Structural Closeout Assistance

Re: Failed Inspection Report

The purpose of this letter is to provide a response to a failed county inspection report dated July 31st, 2023, for the Steamboat Basecamp project located at 1901 Curve Plaza in Steamboat Springs, Colorado. A copy of the inspection report is enclosed for record.

STANDARD LIGHTPOLE ANCHORAGE

BASE PLATE & ANCHOR BOLT DIMENSIONS

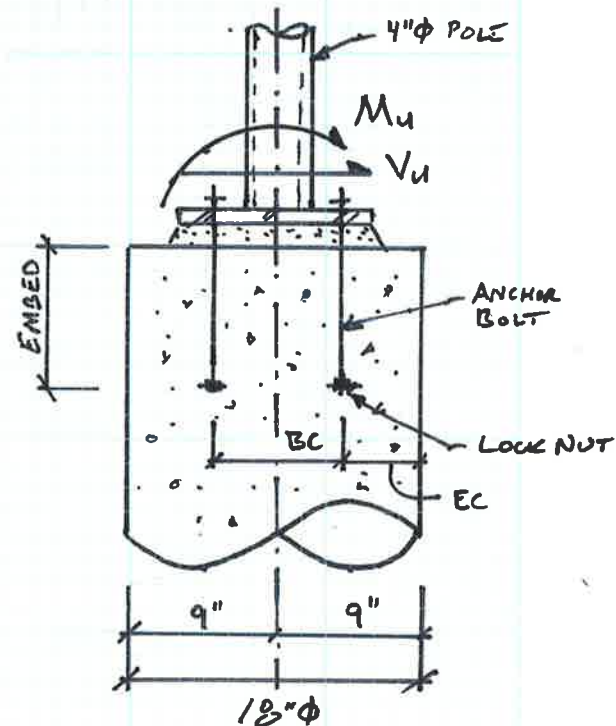
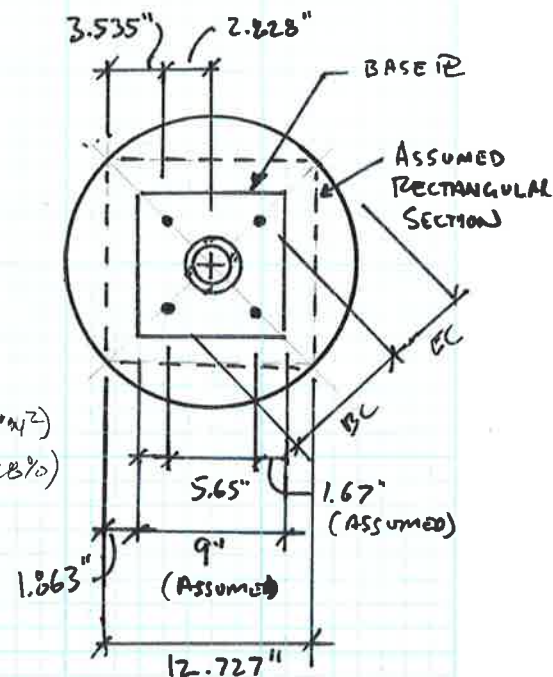
ANCHOR BOLT DIAMETER, $d_b = 5/8"$ ϕ

ANCHOR BOLT GRADE = F1554, GR 36
(ASSUMED)

5/8" ϕ ALL THREAD ROD
w/ 18" EMBED OKAY

(DCR = 28%)
